CITY OF ALBUQUERQUE

**RE: U-Haul
2217 4TH St. NW
Grading & Drainage Plan
Engineer's Stamp Date: 01/28/20
Hydrology File: H14D110**

Based upon the information provided in your submittal received 03/31/2020, the Grading & Drainage Plan **is not** approved for Building Permit and SO-19 Permit. The following comments need to be addressed for approval of the above referenced project:

U-HAUL
4TH AND I-40
GRADING AND DRAINAGE
PLAN

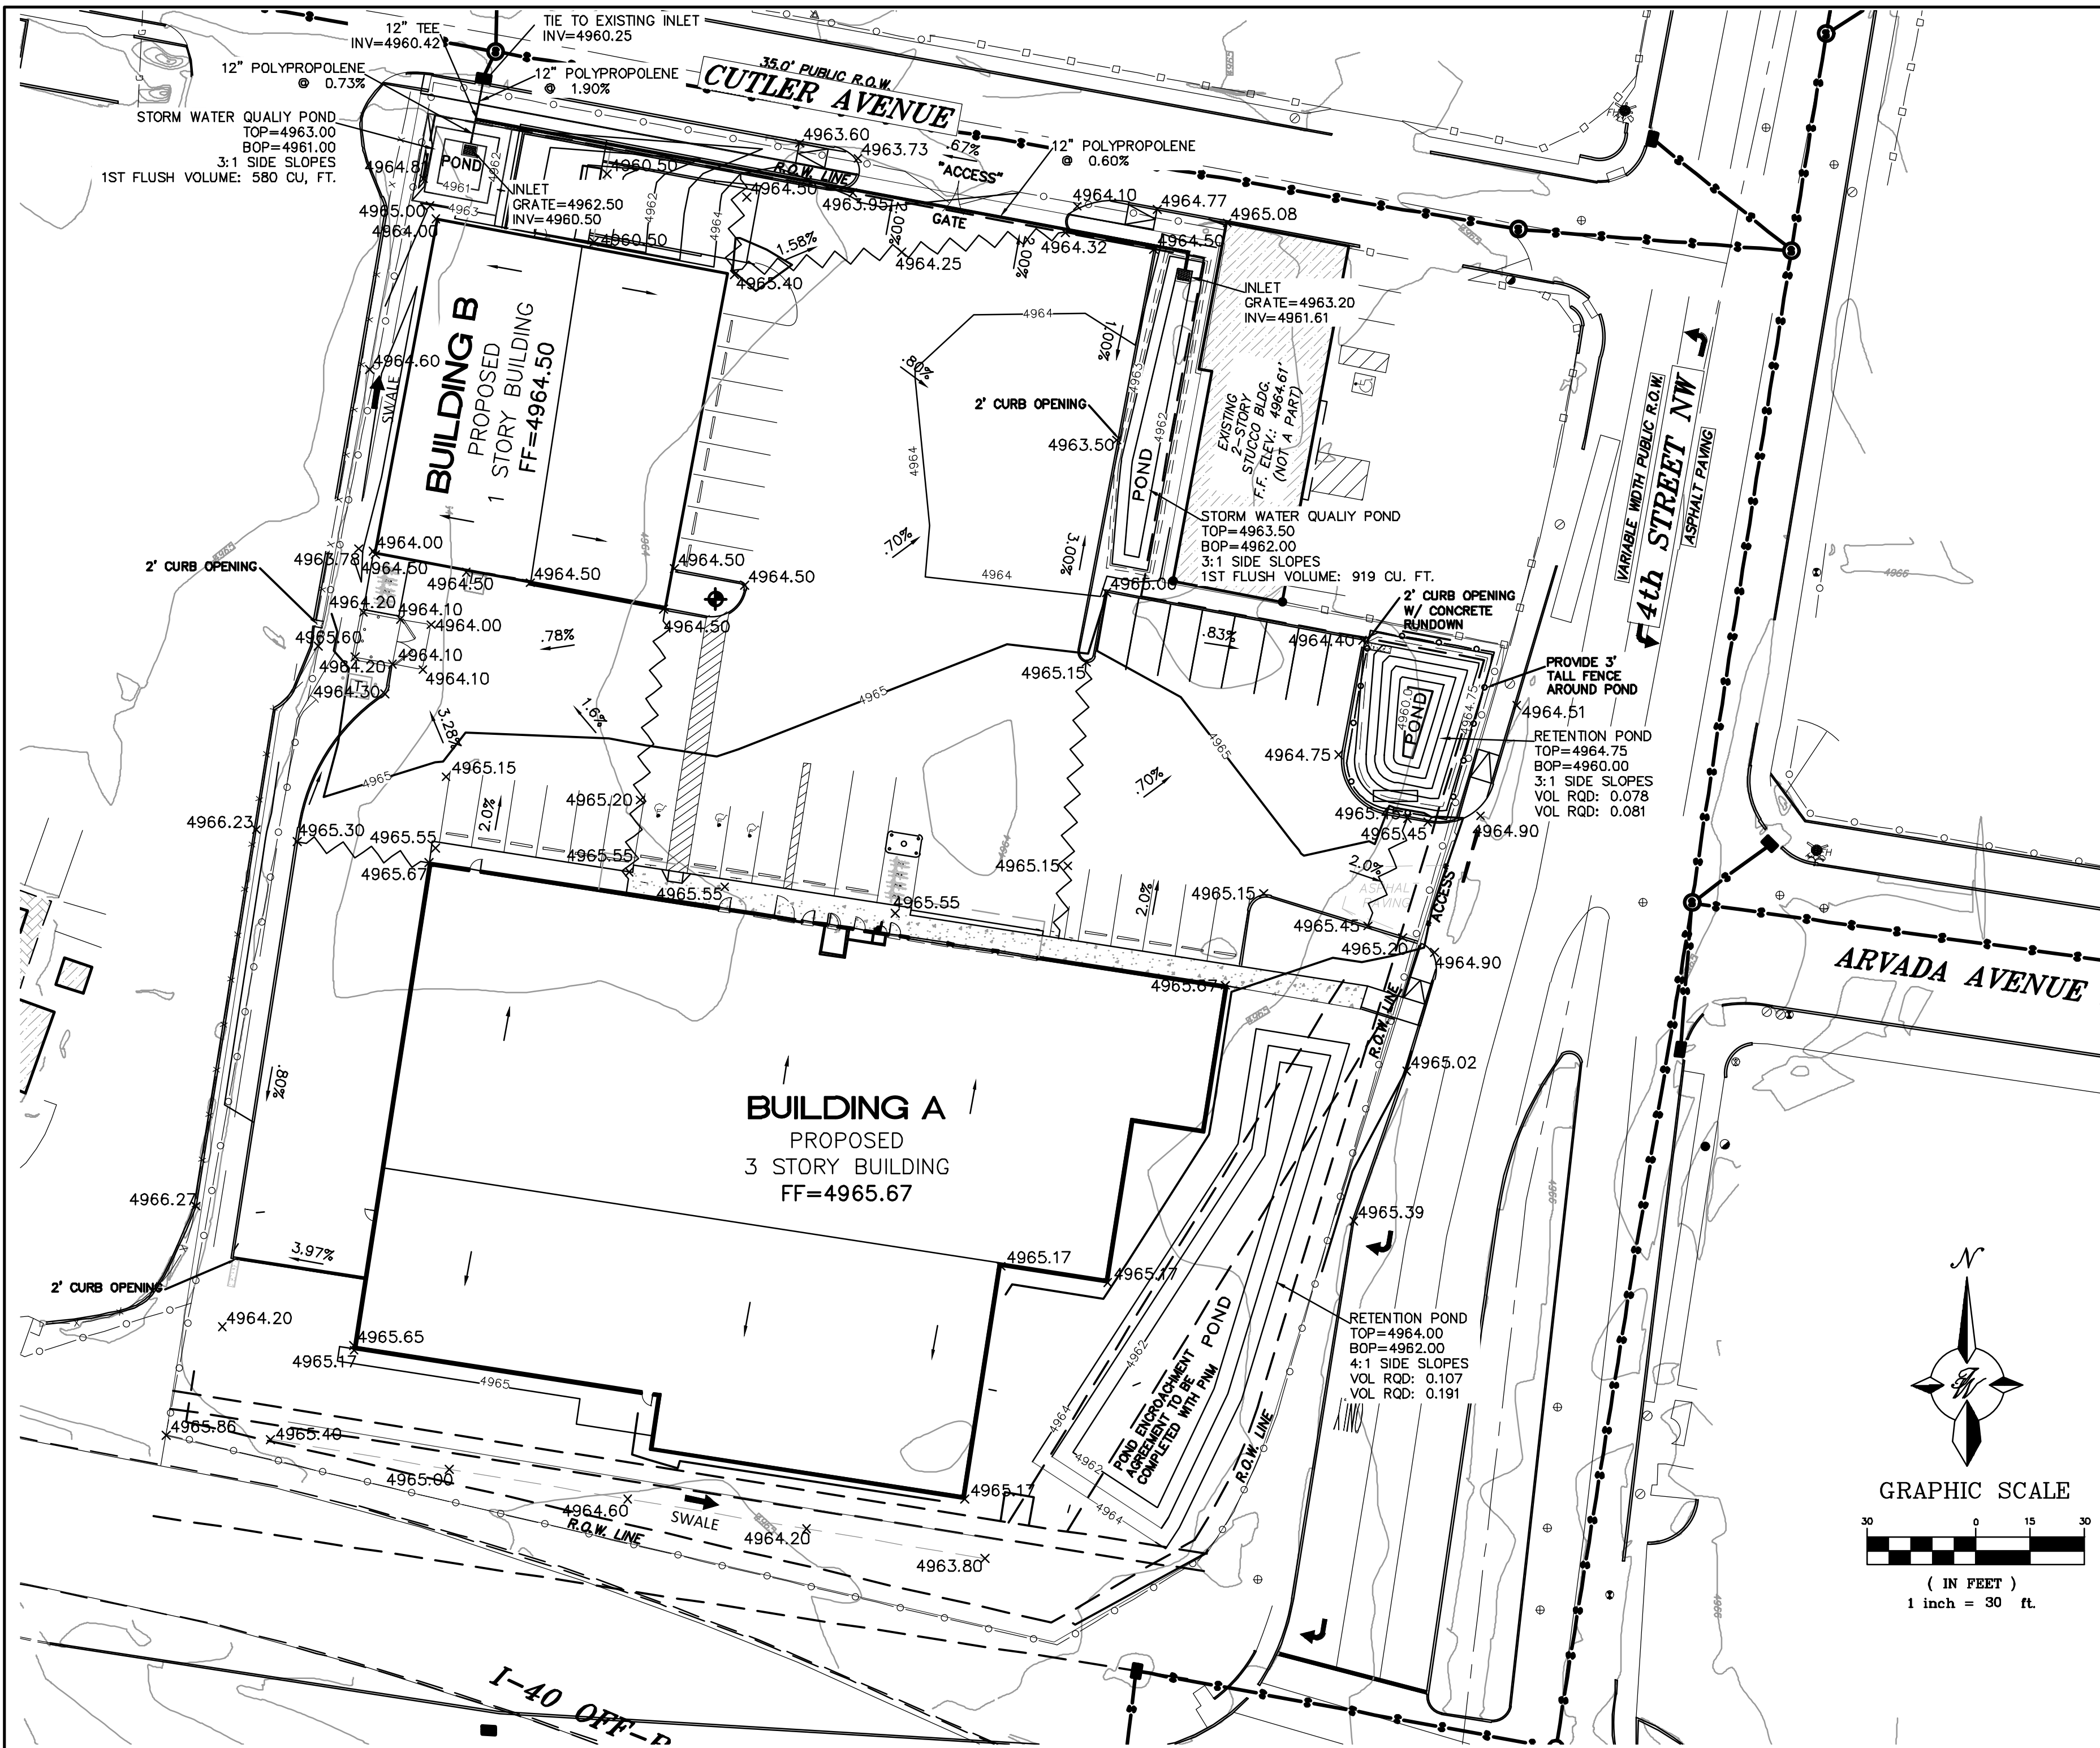
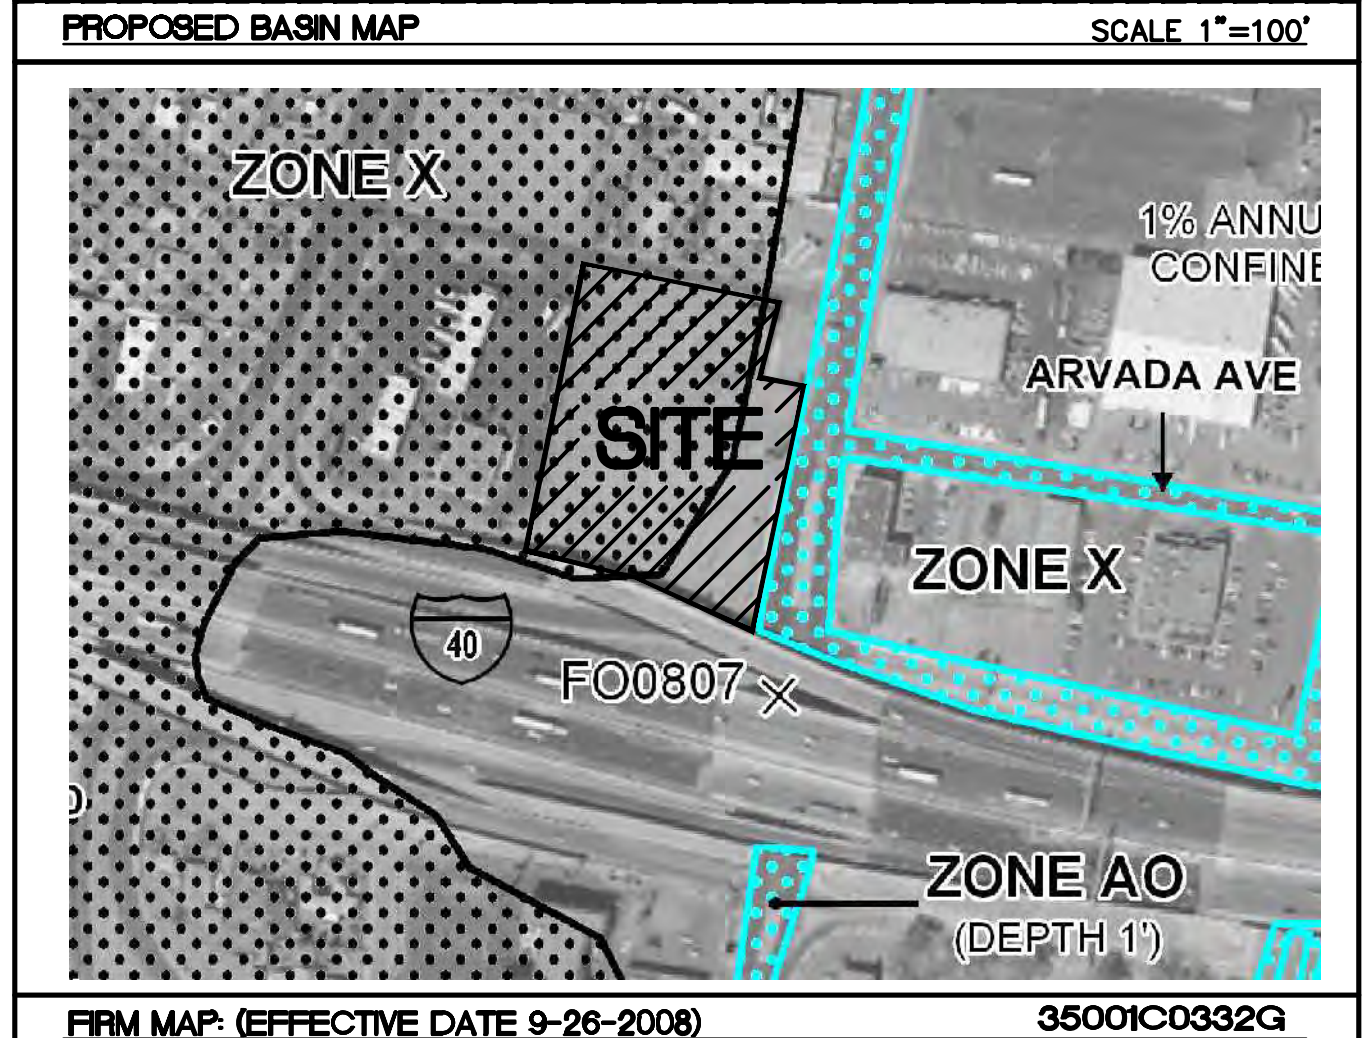
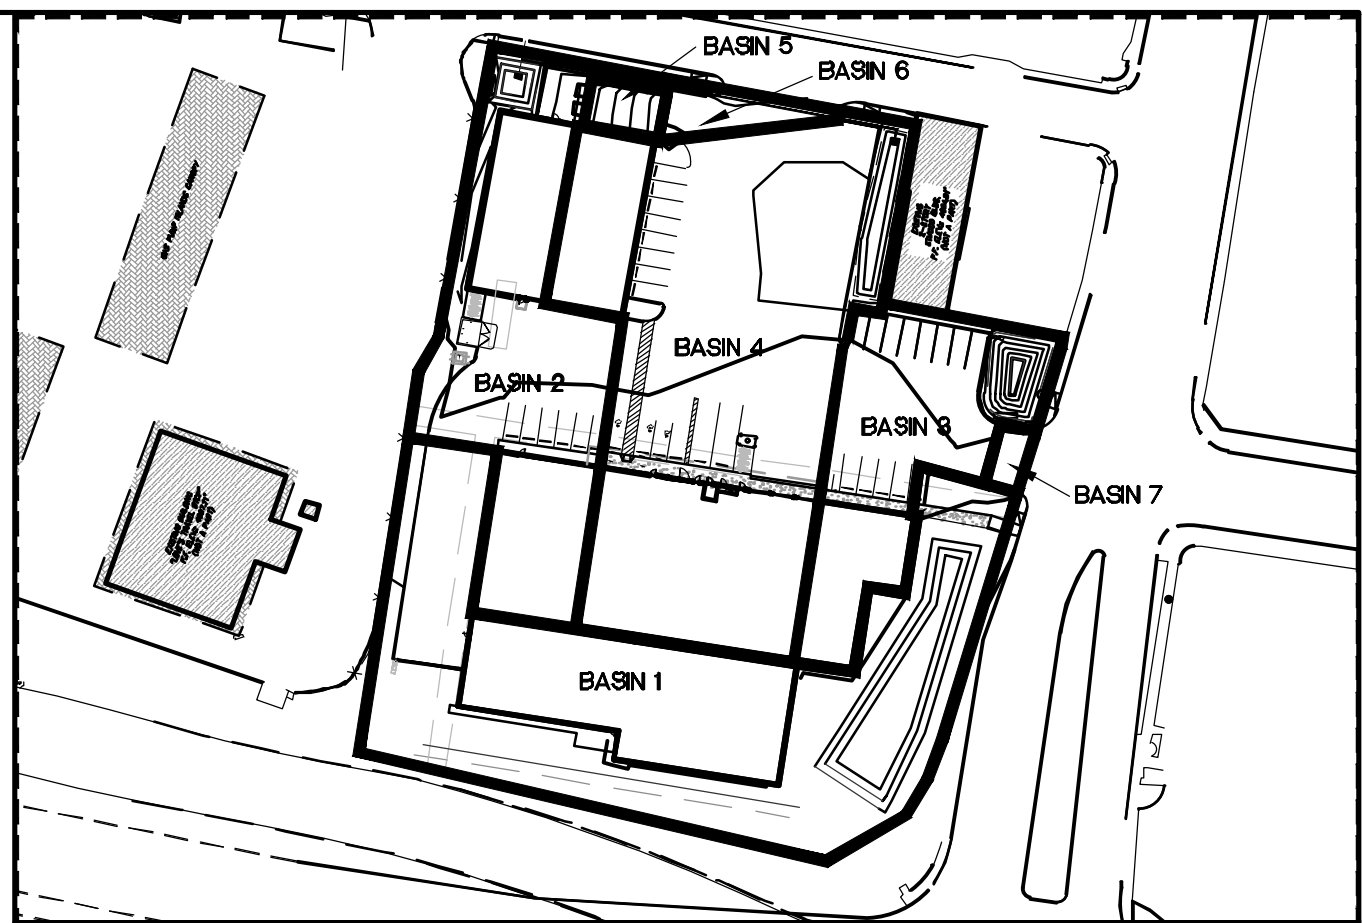
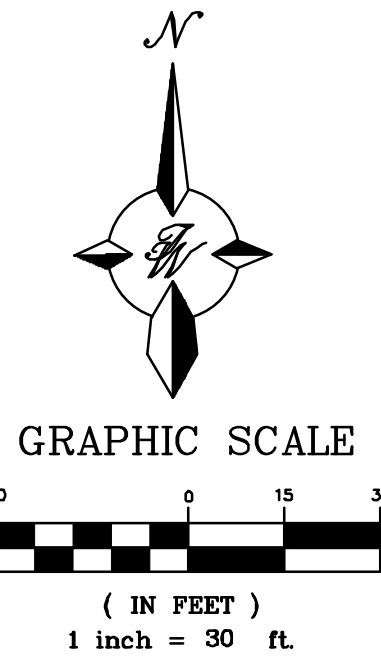
1. Please use the latest SO-19 Notes. See attachment.
2. Please update your use of "First Flush". This is an old 1990s term and please update it with "Stormwater Quality" instead.

3. Please provide an emergency spillway for both retention ponds by way of sidewalk culverts.
4. Please provide a cross section of both retention ponds showing the 100 yr – 10 day volume, top of pond, bottom of pond, and the elevation of the emergency spillway (sidewalk culvert).

5. Please add the broad crest weir equation (equation 6.60 in the DPM) for the 2 ft curb cuts and the sidewalk culverts.. A coefficient of 2.7 is typically used for the equation $Q = CLH^{2/3}$.

6. Please reference City of Albuquerque standard detail No. 2236 – Sidewalk Culvert with Steel Plate Top at the sidewalk culvert.
7. Please update the SO-19 Permit Notes. See Attachment.

8. Please show and label the slump pump along with the force main. Also provide the cut sheet for the pump along with the performance curve.
